**TOWN OF BROOKLYN**  
**PLANNING AND ZONING COMMISSION**  
**Regular Meeting Agenda**  
**Tuesday, September 15, 2020**  
**6:30 p.m.**

## **ENGINEERING PLAN REVIEW PERTAINING TO PROPOSED PARKING EXPANSION VACHON CHEVROLET (ASSESSOR'S MAP 41, LOTS 13A & 14) PROVIDENCE ROAD (ROUTE 6) BROOKLYN, CT (March 20, 2020)**

The comments contained herein pertain to my review of plans for a 3-lot residential subdivision on Church Street in Brooklyn, Connecticut, consisting of five (5) sheets, prepared for David P. Bell and Nancy M. Bell by PC Survey Associates, LLC and Killingly Engineering Associates, dated April 2020 with revision date of July 6, 2020 (Sheets 1-4). My comments are as follows:

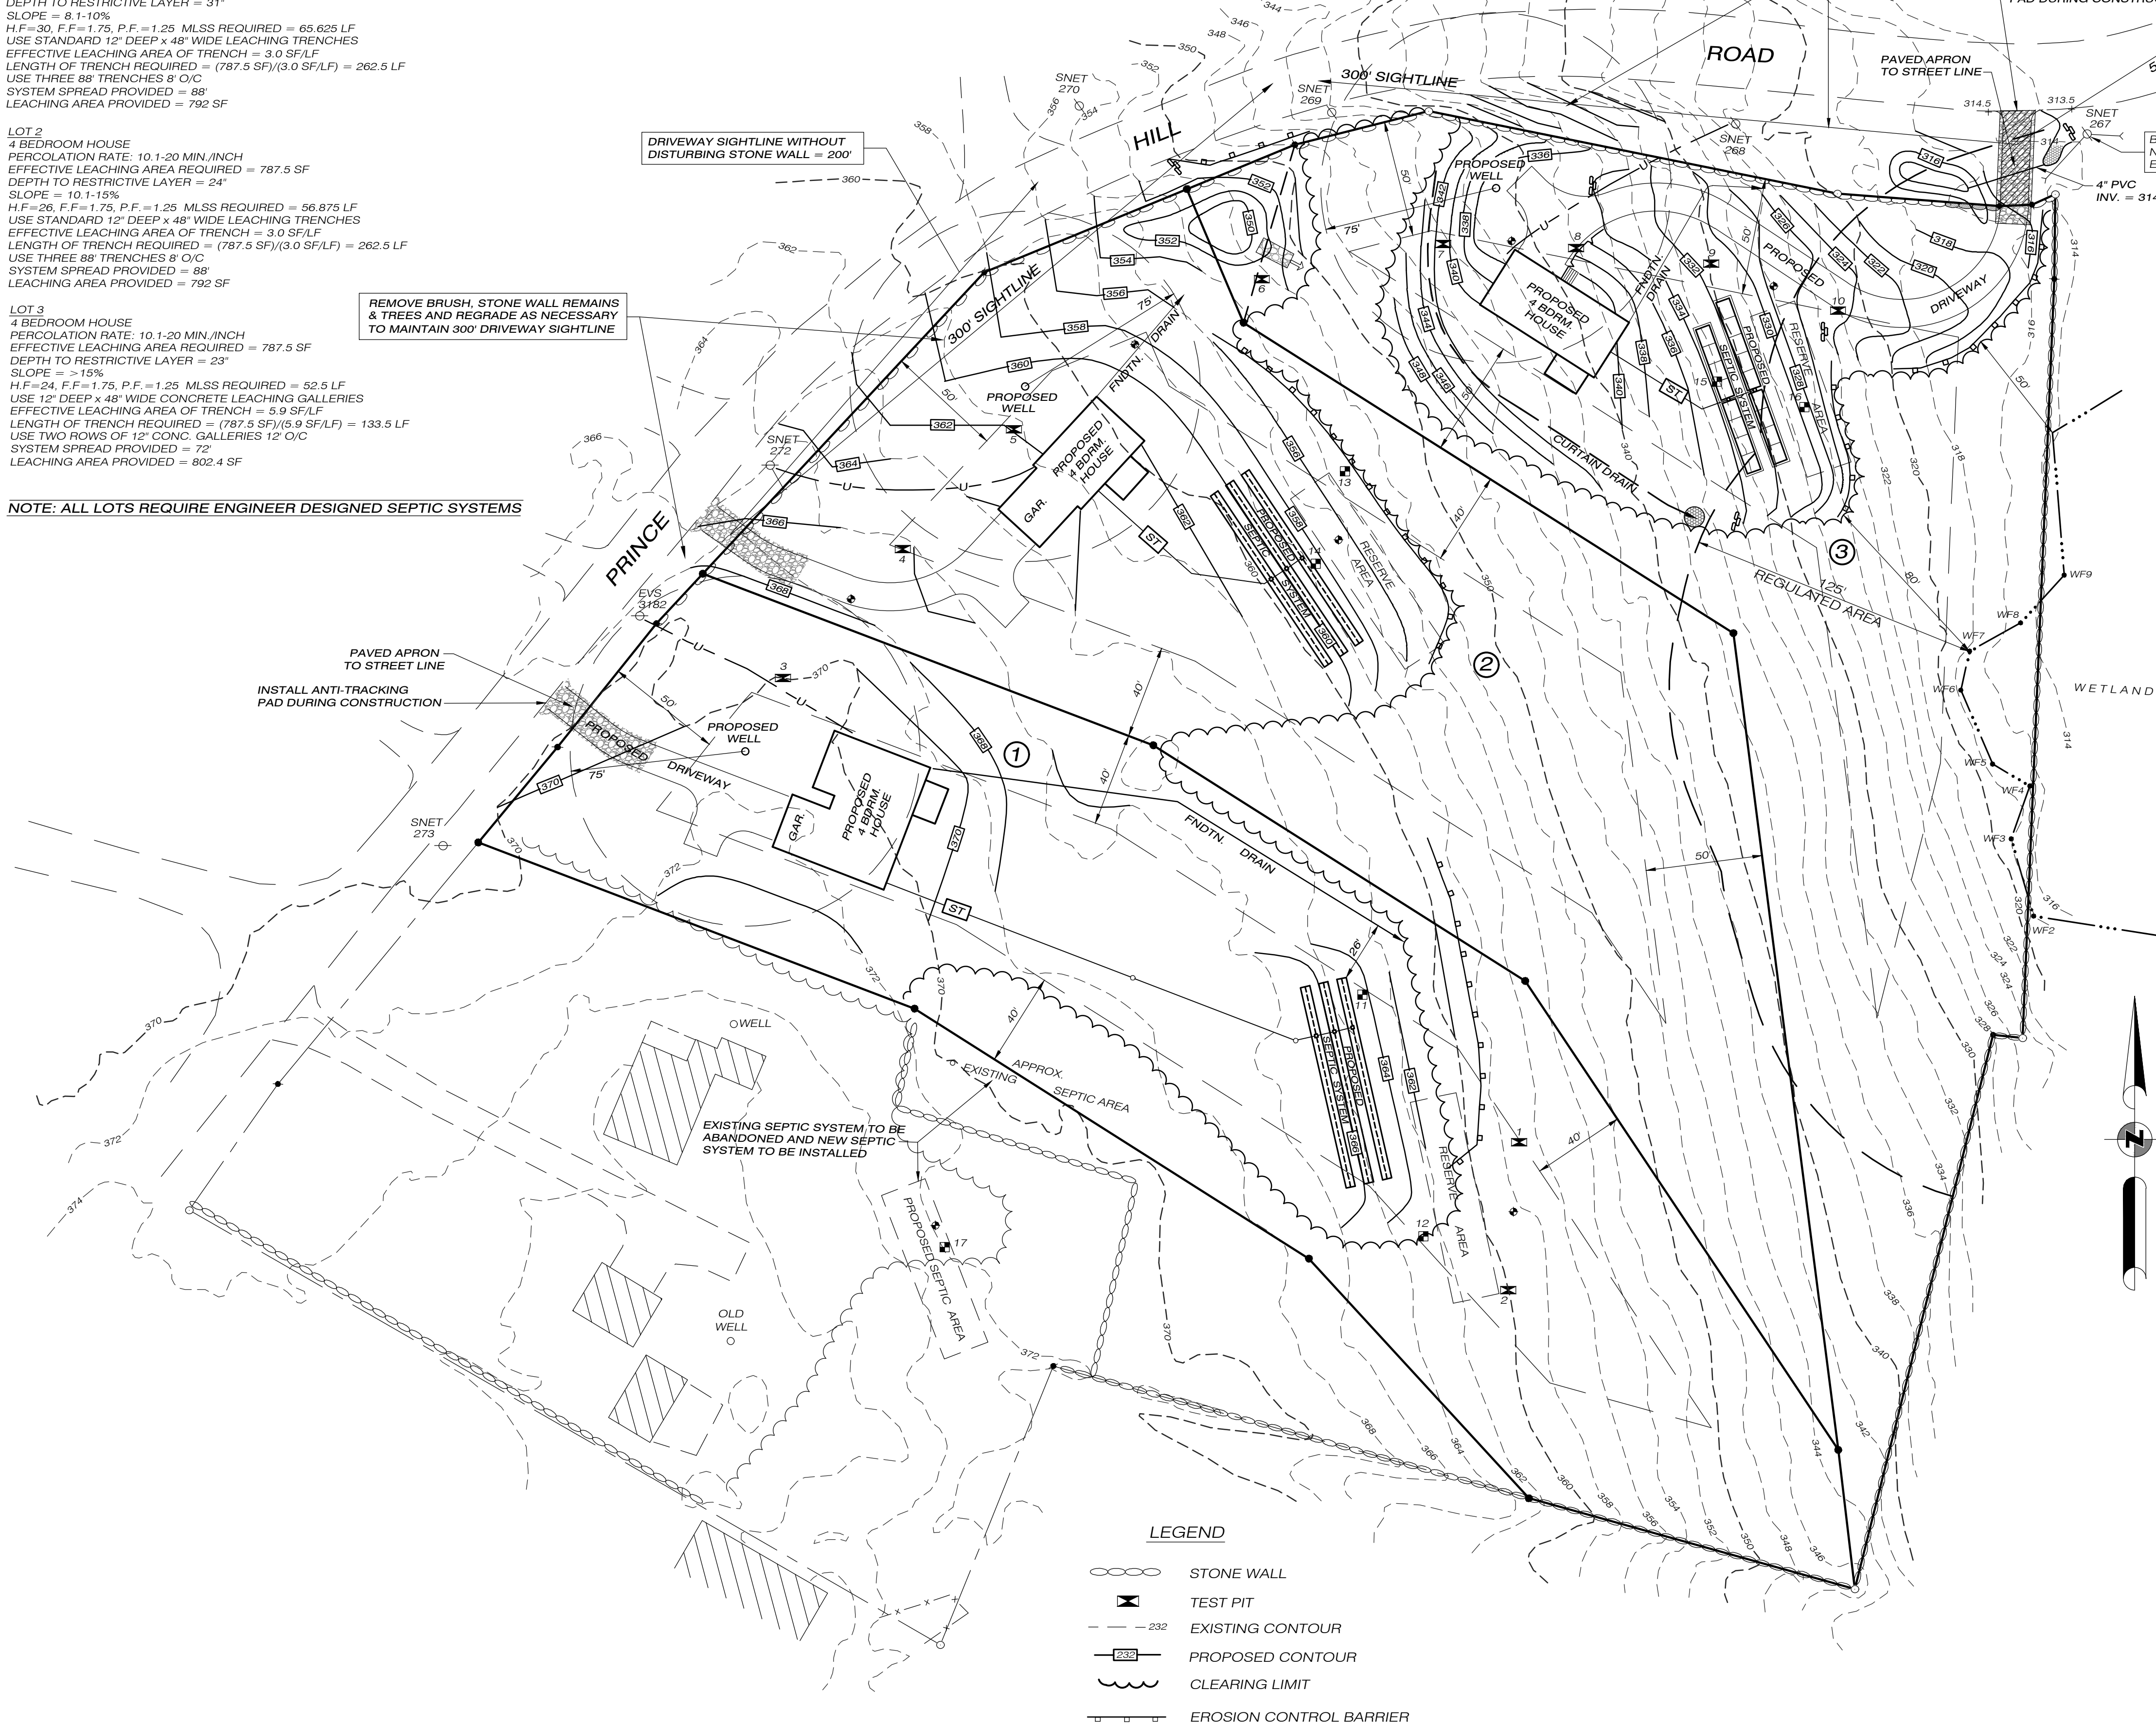
3. On Sheet 3 of 4 there is a note under the test hole data columns stating that *"Additional percolation tests at depths above restrictive layer to be performed on Lots 1 and 3 at the time of lot development."* As far as I know, the need for this note remains unexplained. The consultant submitted a letter from the Northeast District Department of Health, dated July 20, 2020 and addressed to David and Nancy Bell, regarding the feasibility of future development of their land to be subdivided into three (3) lots with 4 bedroom houses. Said letter makes no mention of performing additional percolation tests and, therefore, I would like an explanation of what this means from the Applicant's consulting professional engineer (engineered septic systems are required).
